TECHNICAL NOTE

Project Title: Beane Solar Farm

Report Reference: 794-PLN-TRP-JNY11727-04

Beane Solar Farm Technical Note

FOR
INFORMATION
ONLY

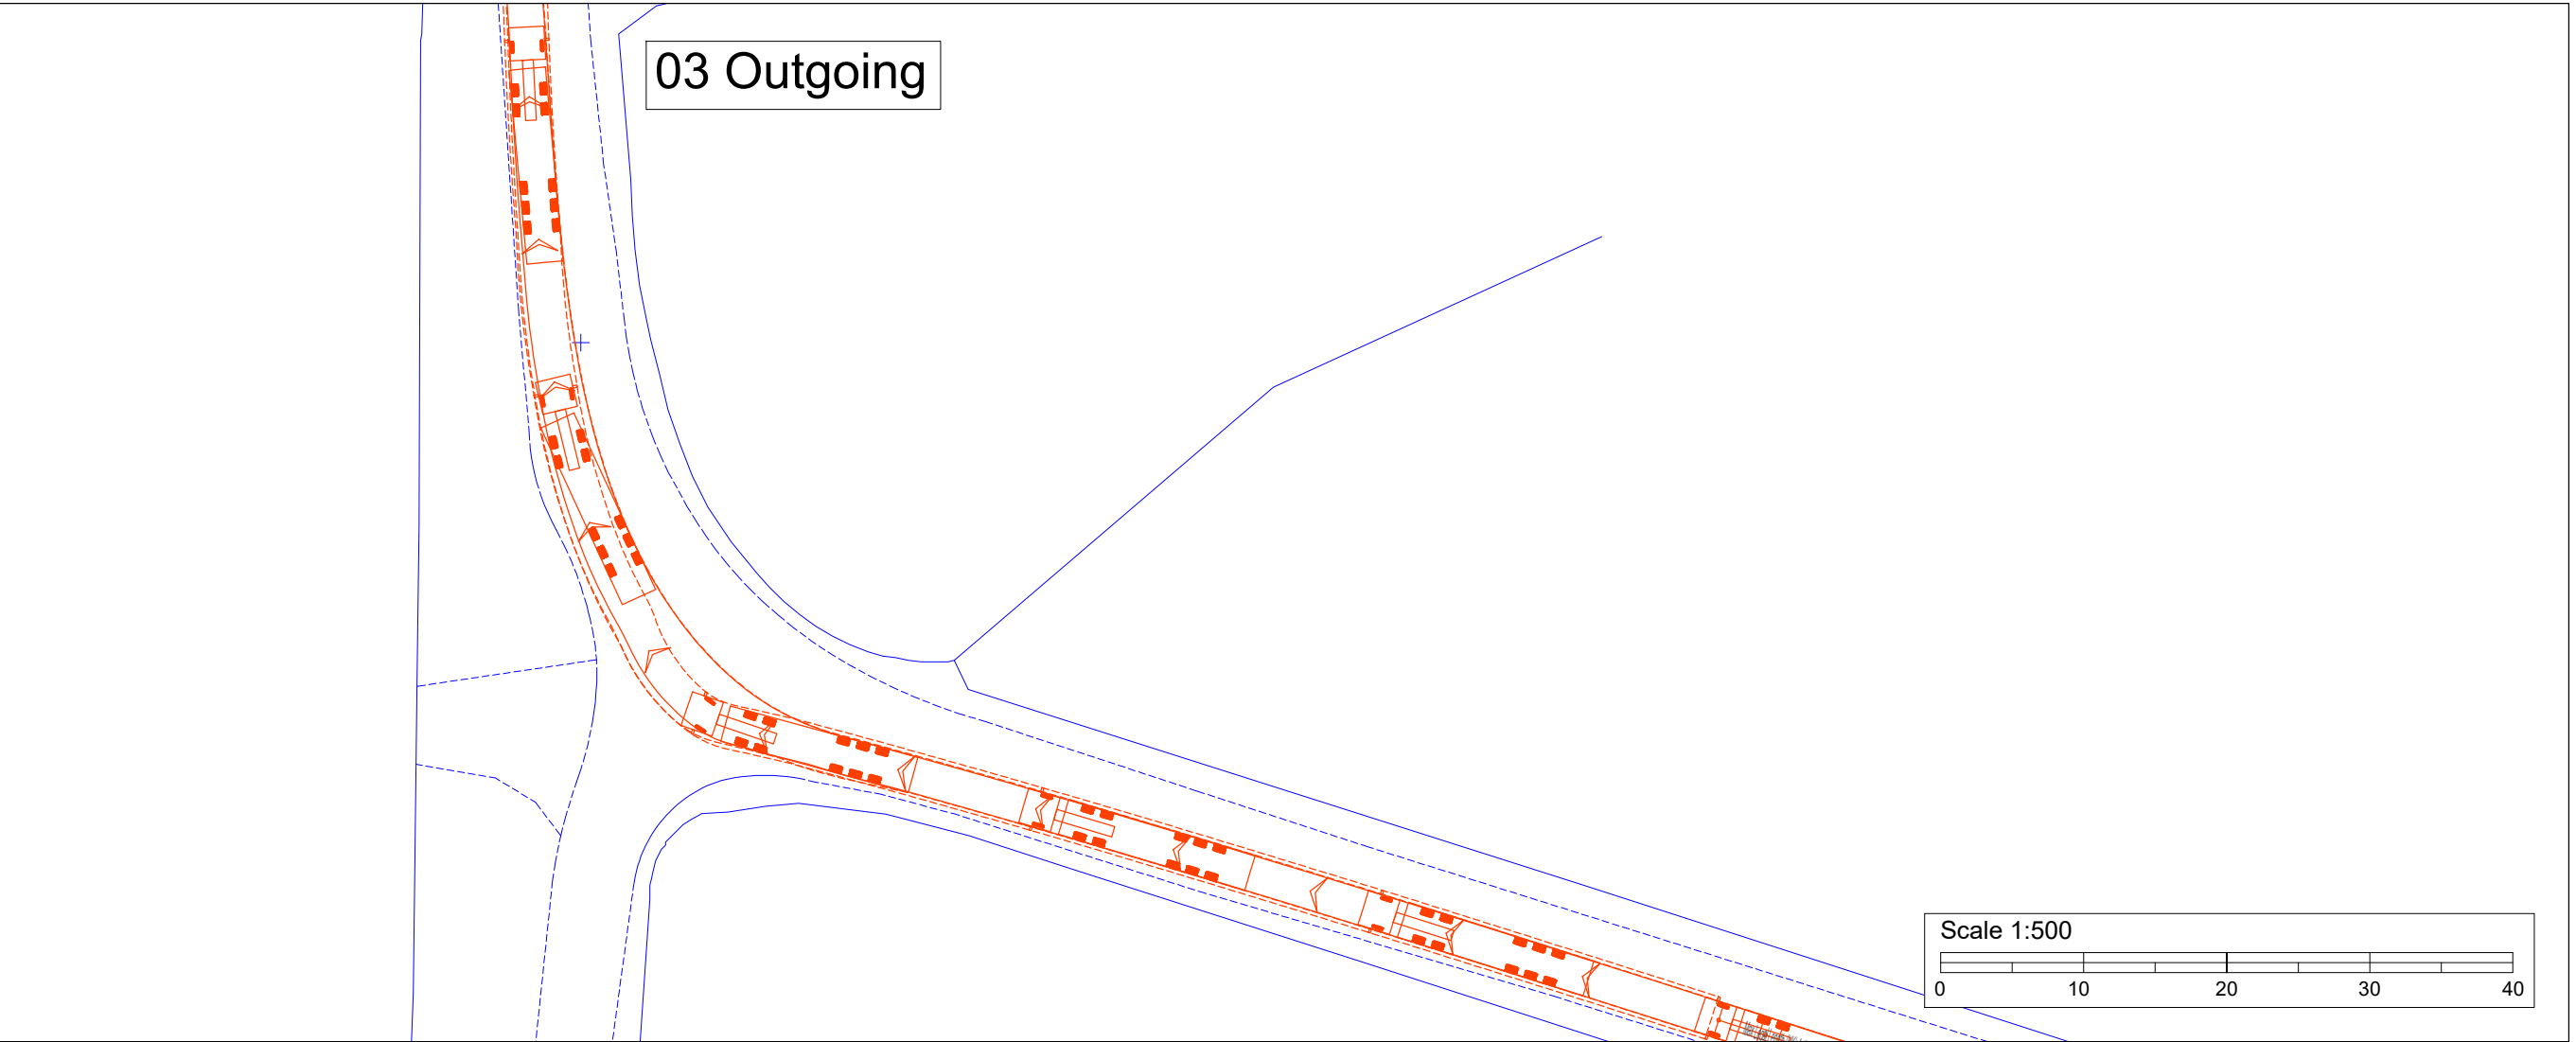
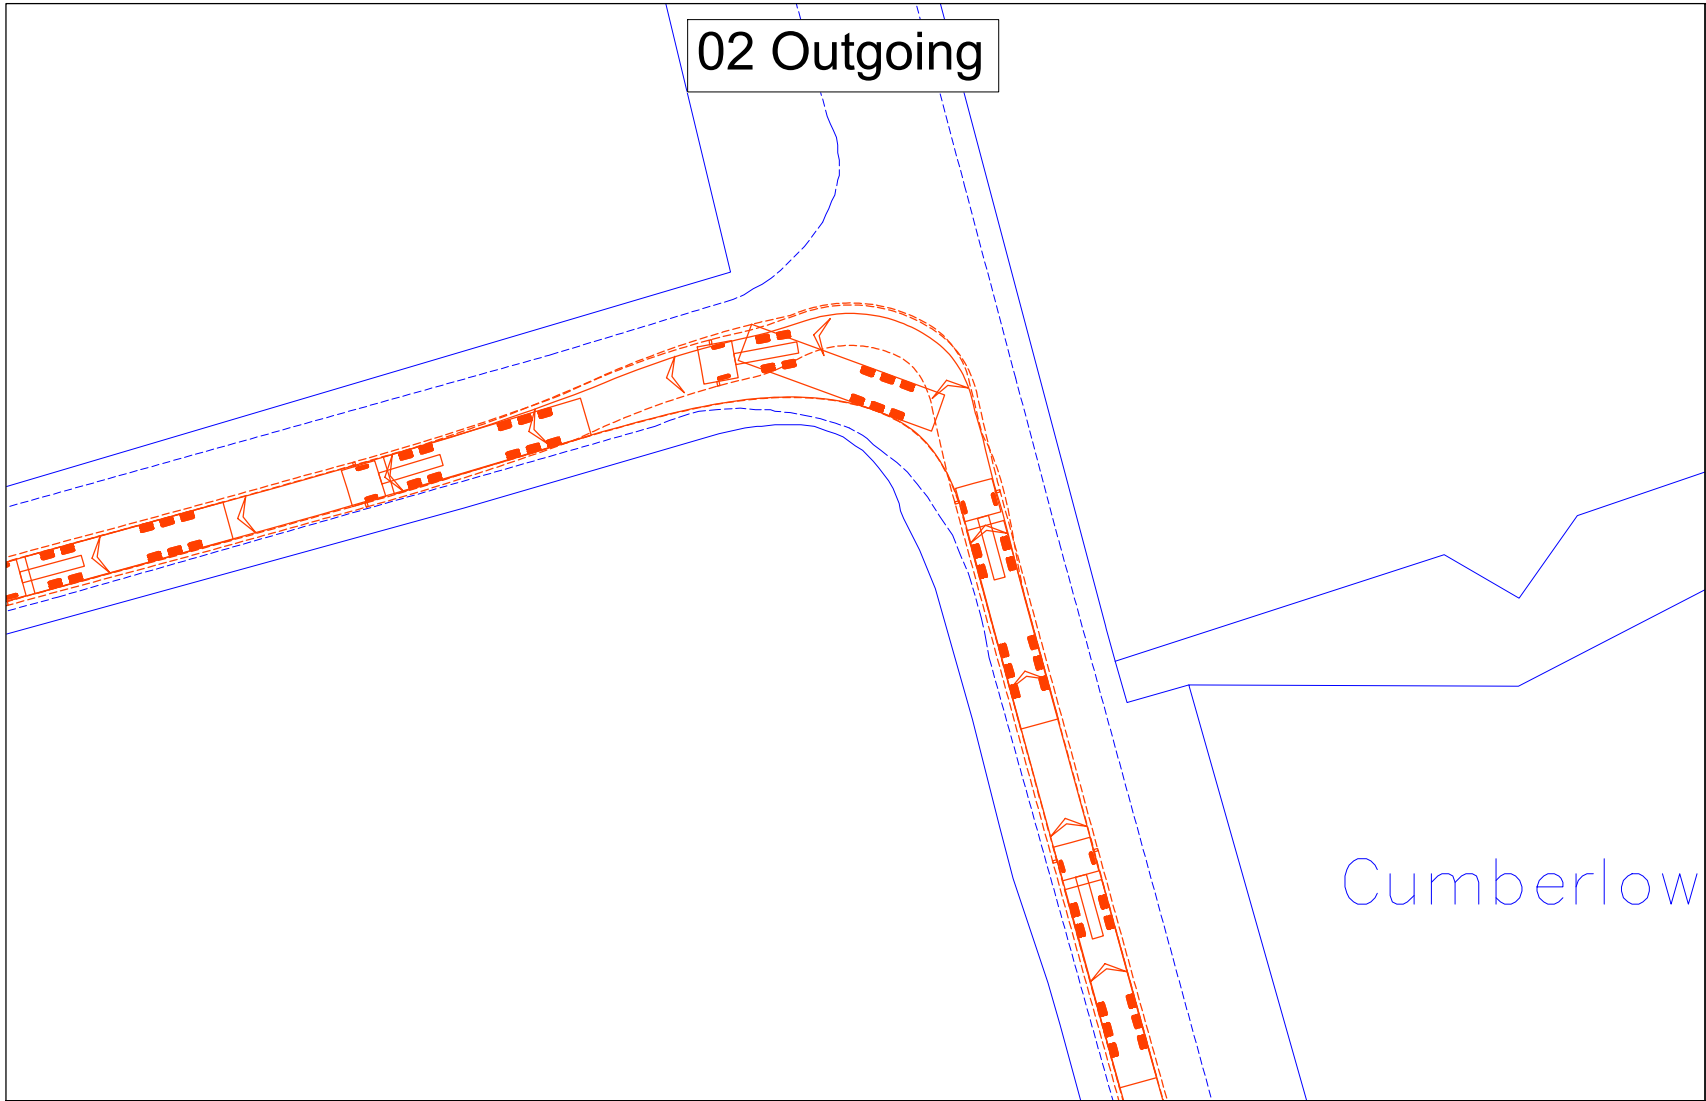
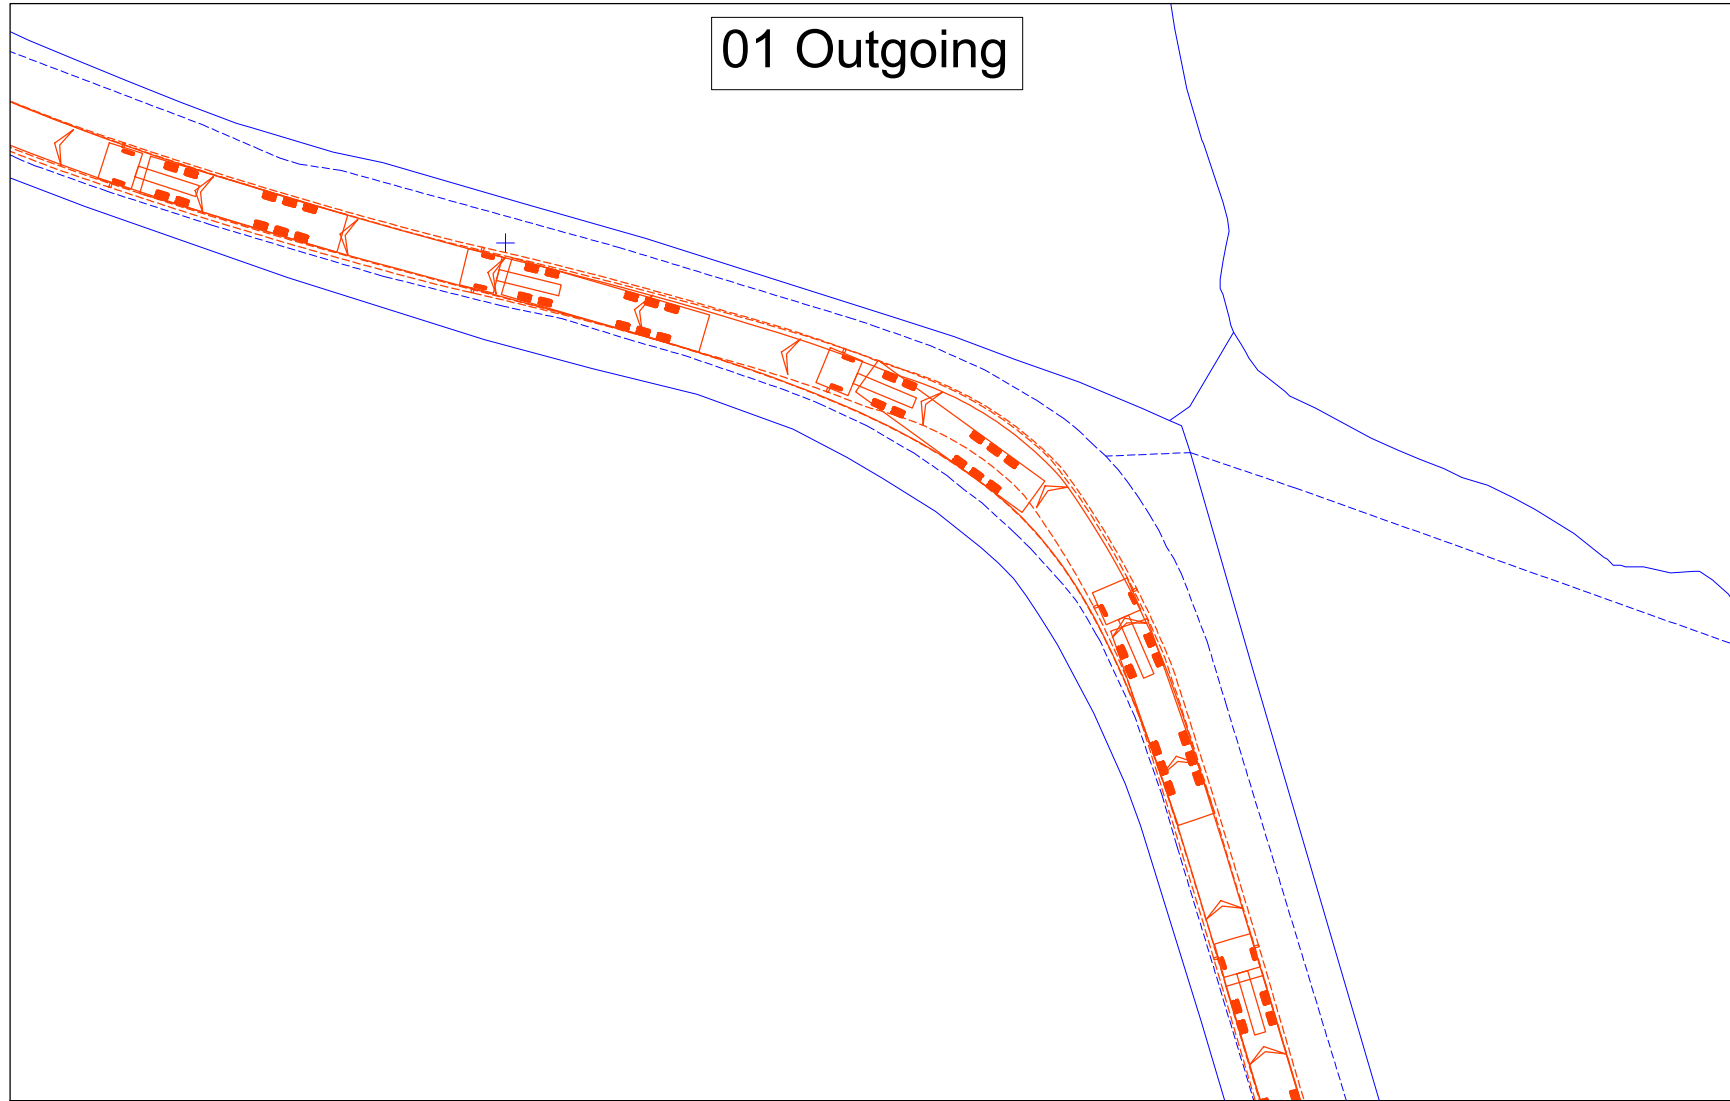
- There is significant concern with construction vehicles exiting the site and driving North West along the A507. Parts of this route is deemed to not be acceptable for large HGV's such as 16.5 metre lorries. Significant concern is Baldock town centre and the Clothall road Junction with the A507 both of these along with this whole route west out of the site will need to be swept pathed."

- 1.29 It should be noted that all construction HGVs arriving and departing to the west will arrive via the A1(M) junction, or the A505 as shown on Figure 6 of the CTMP. On this basis, no construction HGVs will route through Baldock town centre.
- 1.30 A swept path analysis has been undertaken of the A507 to the northwest and southeast of the site, inclusive of the Clothall Road junction, shown at **Appendix 5A-D**, which demonstrates that construction HGVs can travel safely along the proposed access route.
